UNIVERSITY OF FLORIDA  
TRAINING REACTOR  
LICENSE NO. R-56  
DOCKET NO. 50-83

SUBMITTAL OF RESPONSES DATED AUGUST 4, 2006,  
TO NRC REQUEST FOR ADDITIONAL INFORMATION  
FOR THE CONVERSION FROM HIGH-ENRICHED  
URANIUM TO LOW-ENRICHED URANIUM FUEL

Amendment 26  
(previously Amendment 25)  
UFTR Technical Specifications  
Addendum 2

University of Florida Training Reactor, Facility License: R-56, Docket No. 50-83  
Request for Change in Technical Specifications Approving HEU to LEU Conversion  
With Responses to Requests for Additional Information

Figure 1 – Modified fuel assembly design by BWXT to include the “comb” design

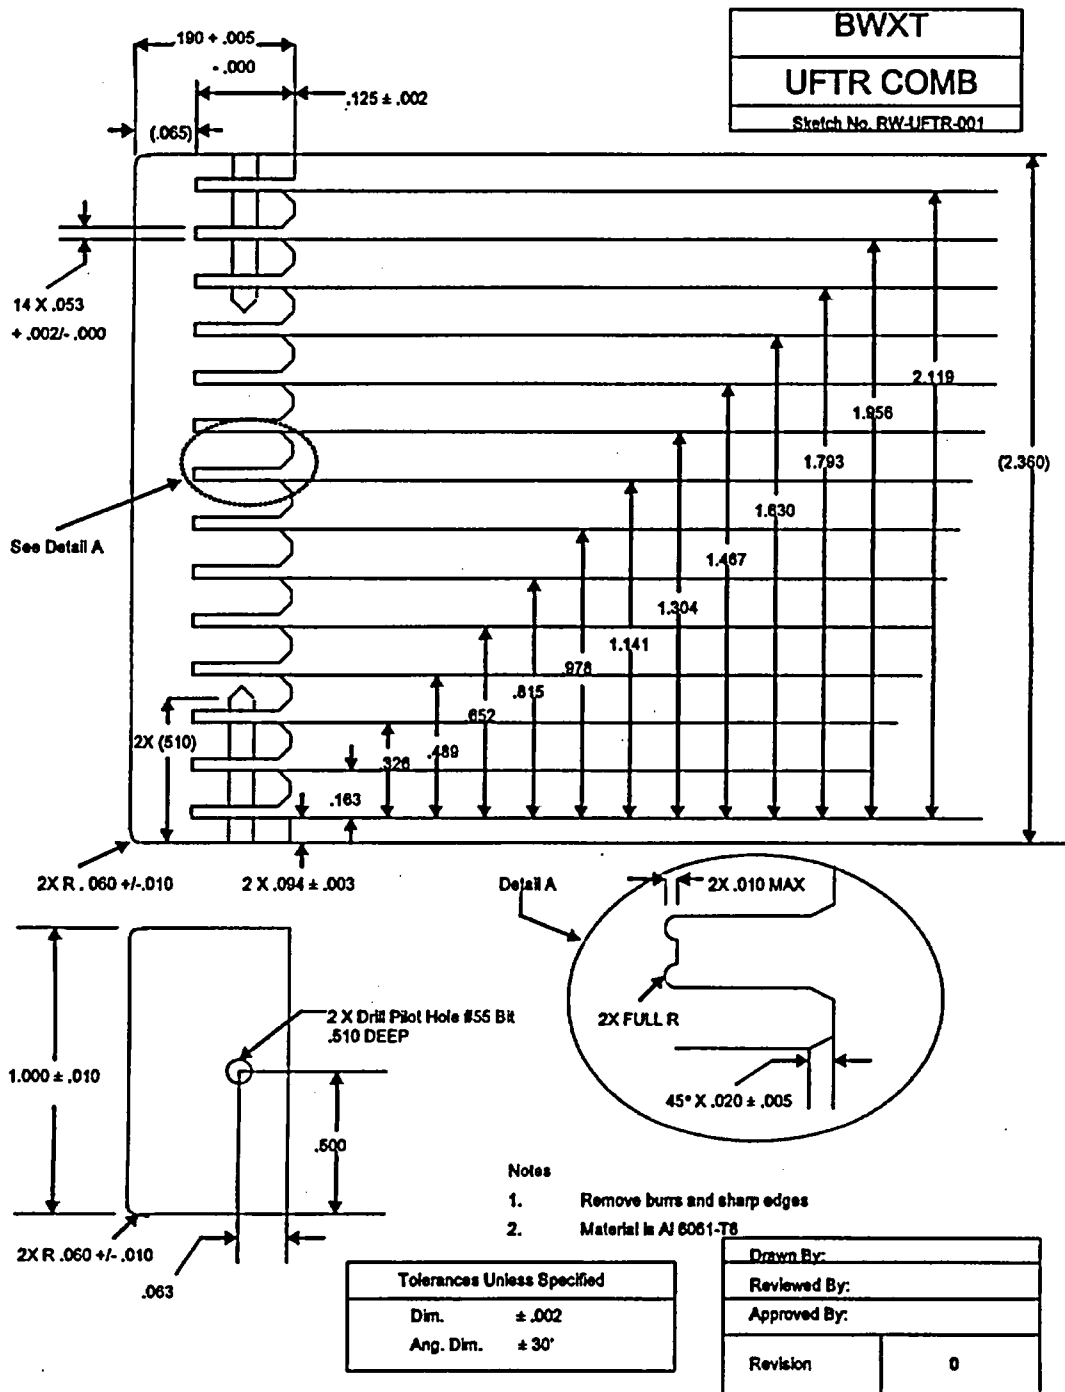
Initial inspection and measurement of LEU fuel assemblies manufactured by BWXT in July 2006 showed a variation in the water channel thickness that was larger than expected. In this design, the ends of the plates are separated by aluminum spacers and are bolted together. Aluminum spacers are welded onto the edges of the plates at about half their height. This fuel assembly design has been modified by BWXT to include the "comb" design shown in Figure 1 that will physically separate the fuel plates at the nominal quarter-points along the fuel plate length. In this modified design, the tolerance on the minimum water channel spacing is expected to be a maximum of  $\pm 20$  mils. The nominal water channel spacing at the bolted ends of the fuel assembly on the manufacturing drawings is 110 – 112 mils, giving a minimum water channel spacing of 90 mils.

The steady-state thermal hydraulic analysis described in Ref. 2 assumed hot channel factors based on a 1 mil tolerance for the water channel spacing, as shown on the manufacturing drawings at the bolted ends of the fuel assemblies. In the model, the ends of the fuel plates were assumed to be in contact with the fuel box wall. These new analyses account for two effects – the larger tolerance on the water channel spacing described above and the repositioning of the fuel assemblies in the fuel boxes due to the thickness of the combs extending beyond the edges

of the fuel plates. The combs introduce into the computer model another bypass channel pathway that is located between the fuel plate ends and the box wall. In these new analyses, the ends of the fuel plates are moved away from the wall of the fuel box by 0.065 inches - the height of the comb above the "teeth", as shown in Figure 1.

However, the newly created slot is actually blocked by the width of the comb (0.190 inches), at the quarter-points along the length of the assembly. There will be a small bypass flow through this pathway that is conservatively accounted for by including it as a clear channel, ignoring the blockage created by the presence of the combs. The pressure drop introduced by the combs is not accounted for because it is very small. As a result, the computed coolant flow through the heated channels will be reduced, and the ONB margin and other parameters will be conservative. The presence of the comb also reduces the width of the central channel slot between fuel assemblies. This is a significant beneficial change because it reduces the bypass flow through the central slot.

The actual minimum water channel spacing of each water channel in each finished fuel assembly will be measured by BWXT and made available by August 10, 2006. In case any one of the channel spacings is less than 90 mils, another comb will be added to maintain a minimum channel spacing of 90 mils.

Figure 3. True Power versus True Flow Rate at Which ONB Occurs with 10 mil Tolerance on Water Channel Spacing and Repositioning of Assemblies in Fuel Box to Account for Thickness of Combs.

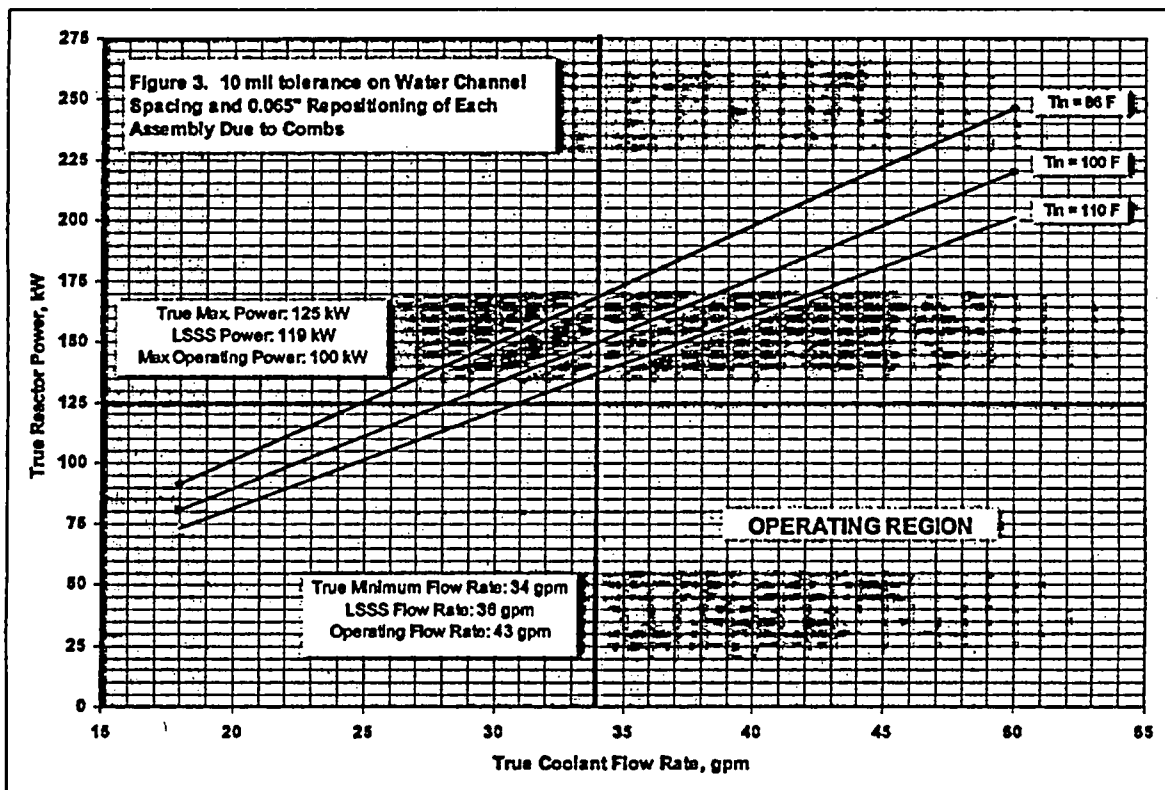
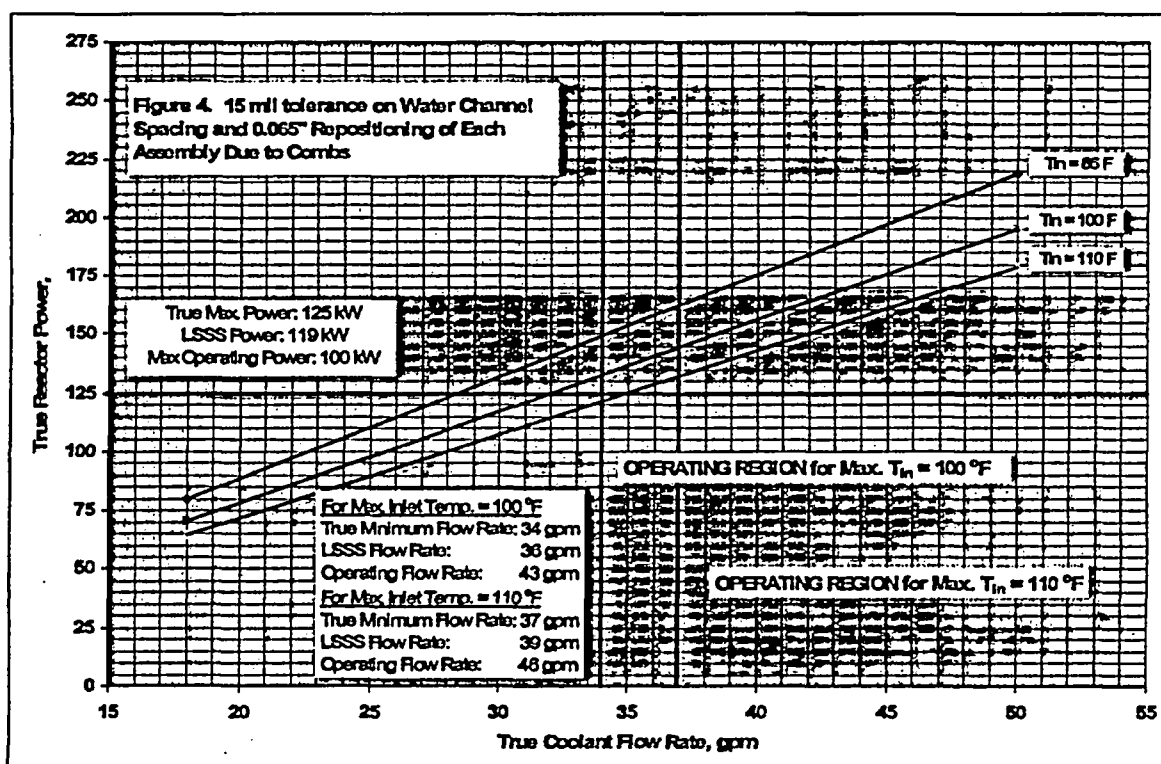
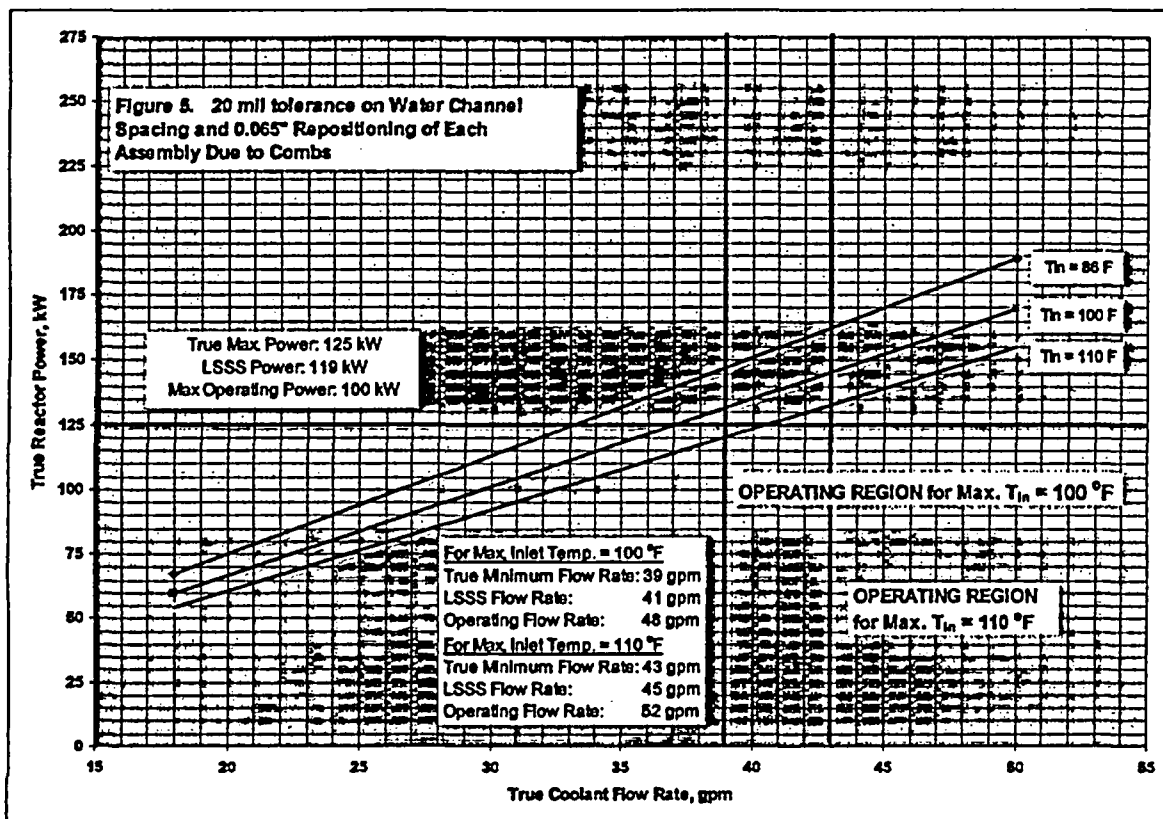
The new power versus coolant flow rate curves for water channel spacing tolerances of 10 mils, 15 mils, and 20 mils, along with repositioning of the fuel assemblies in the fuel box to account for the thickness of the combs are shown in Figures 3, 4, and 5, respectively.

Based on these results, two sets of key flow rate settings are proposed, depending on the maximum value of the average inlet temperature:

Since a measured minimum water channel spacing of 90 mils (20 mil tolerance) is anticipated on a number of the LEU fuel assemblies being re-worked by BWXT, the following values for key coolant flow rate parameters are proposed in Table 5. The UFTR Technical Specifications will need to be changed.

**Table 5 – Flow Rate Settings for 20 mil Water-Channel-Spacing Tolerance  
(measured minimum water channel spacing of 90 mils)**

Type of flow rate	True Max. Inlet Temp.	
	100 °F	110 °F
True Min. (gpm)	39	43
LSSS (gpm)	41	45
Operating (gpm)	48	52

Figure 4-16 Integral Blade Worth versus Position for Safety 3 in the UFTR HEU Core.

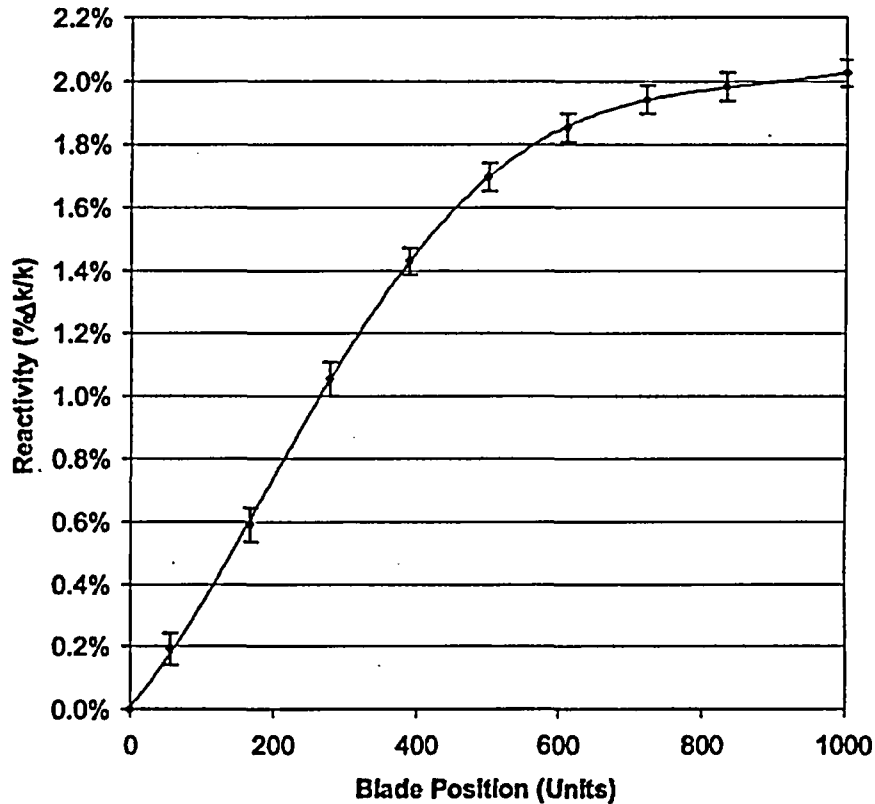
In the June 15th responses to the RAI (docket No. 50- 83), an inconsistency between the control blade worths given in Tables 4-1 and 4-13 was noticed. The current supplement addresses this issue by providing the correct set of values for both tables and the resulting modifications to the relevant pages of the submittal. These modifications were made to ensure that this inconsistency does not appear elsewhere in the submittal.

Figure 4-16 shows calculated the Safety Blade 3 (most reactive blade for HEU core) worth as a function of position.

The UFTR Technical Specifications require that the reactivity insertion rate from control blade withdrawal must be less than 0.06%  $\Delta k/k/s$  when averaged over a 10 second interval. The rate of reactivity insertion resulting from withdrawal of the highest worth blade was approximated by assuming a 100 second (minimum allowed) blade withdrawal time. As shown in Table 4-14, the highest rate of reactivity insertion from withdrawal of Safety Blade 3 is 0.042%  $\Delta k/k/s$ , which meets the requisite UFTR Technical Specification.
